# CITY OF ALBUQUERQUE

**RE: Carlisle & Menaul Commercial Development  
Conceptual Grading & Drainage Plans  
Engineer's Stamp Date: 09/03/2024  
Hydrology File: H16D083F**

Based upon the information provided in your resubmittal received 09/04/2024, the Conceptual Grading & Drainage Plans are Preliminarily Approved for action on the Preliminary Plat.

**CARLISLE AND MENAUL COMMERCIAL DEVELOPMENT BACKBONE INFRASTRUCTURE PROPOSED DMP**

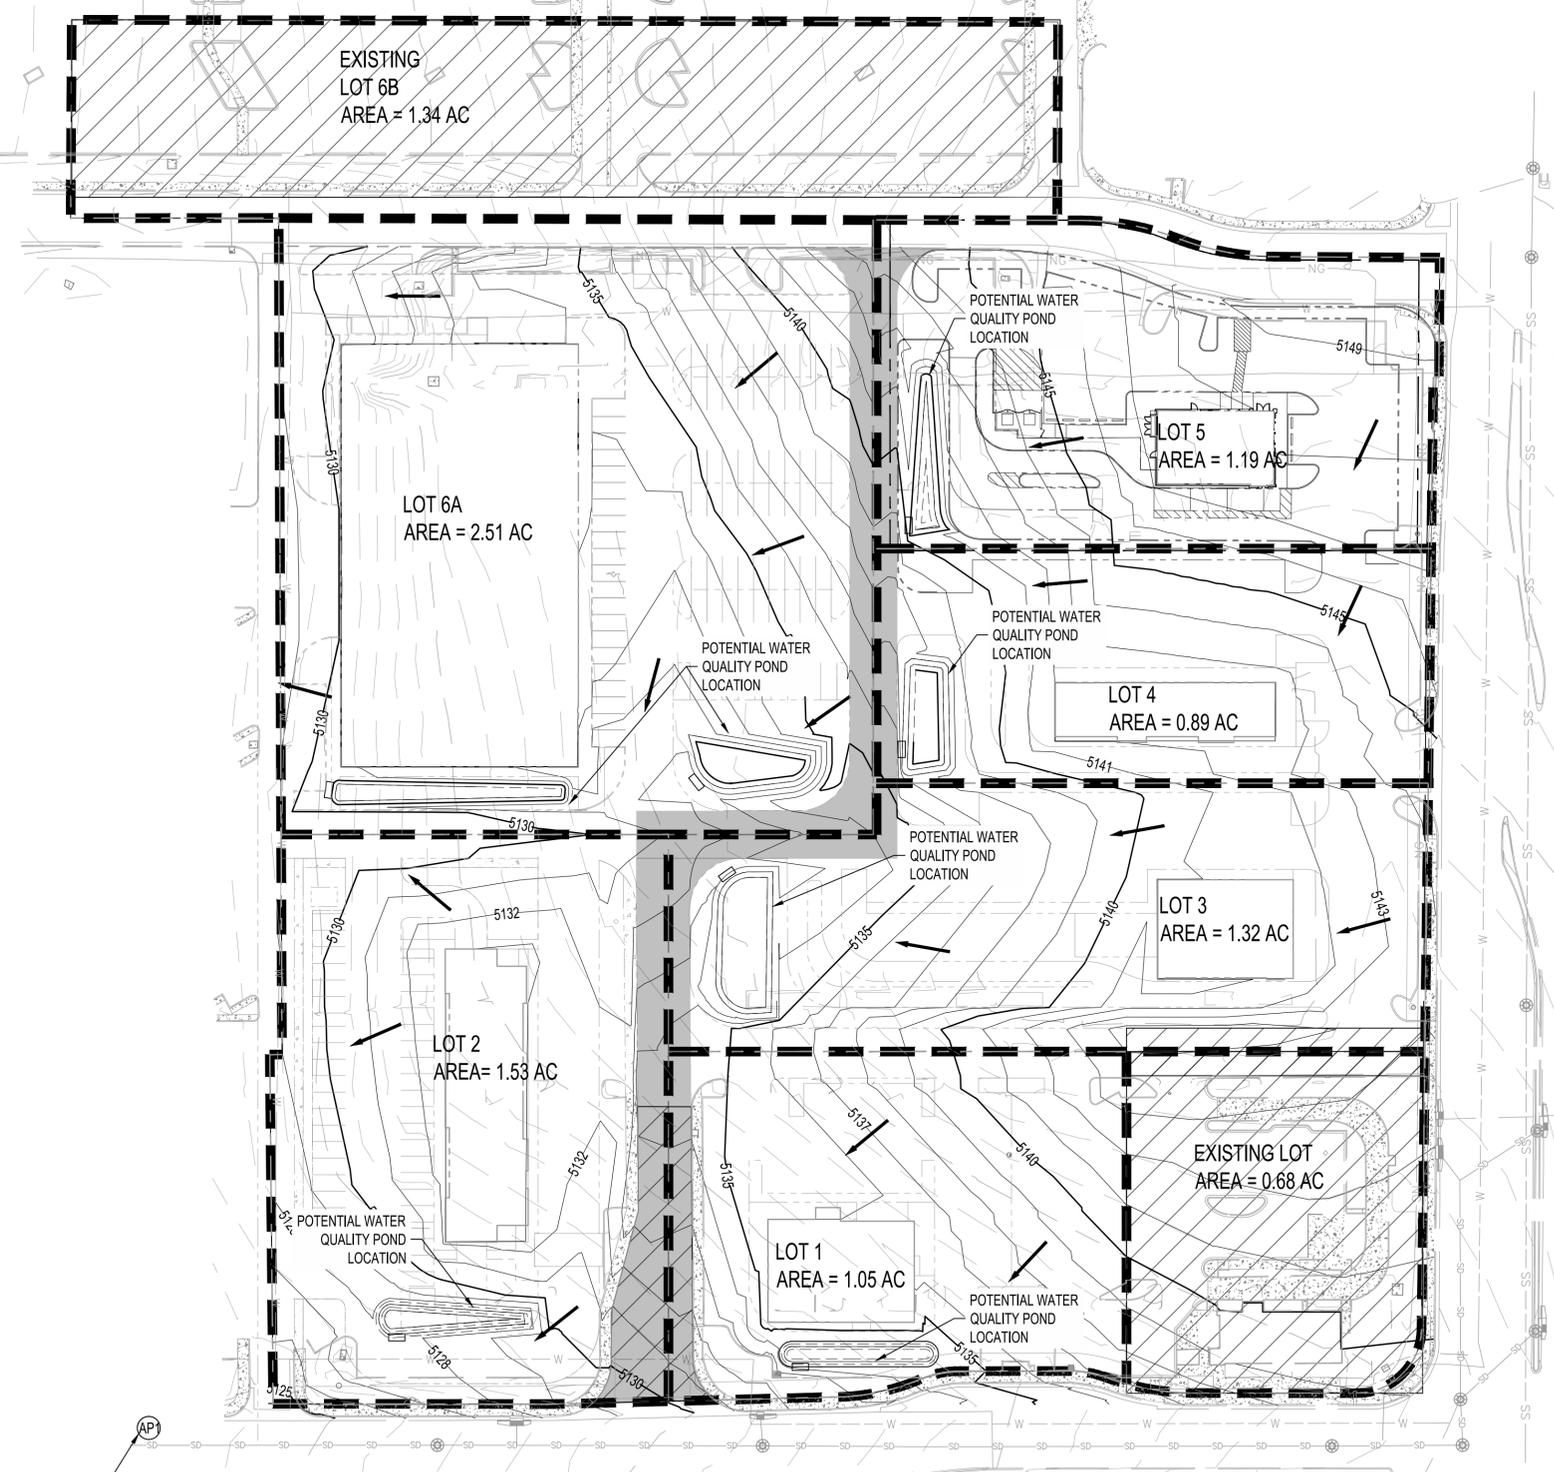
1. Please note, that the Plat will need cross lot drainage easements on Lots 3, 4, 5, and 6A to account for stormwater discharges from proposed water quality ponds.

2. Grading and Drainage plans will be required for each of Lots 1, 2, 3, 4, 5 and 6A to account for each of their own developed flow as well as the cross-lot flows draining into each lot and leaving each lot.

3. Provide management onsite for the Stormwater Quality Volume (SWQV) in accordance with the new drainage ordinance, § 14-5-2-6 (H) enacted 10/2/18 (Council Bill C/S O-18-2).
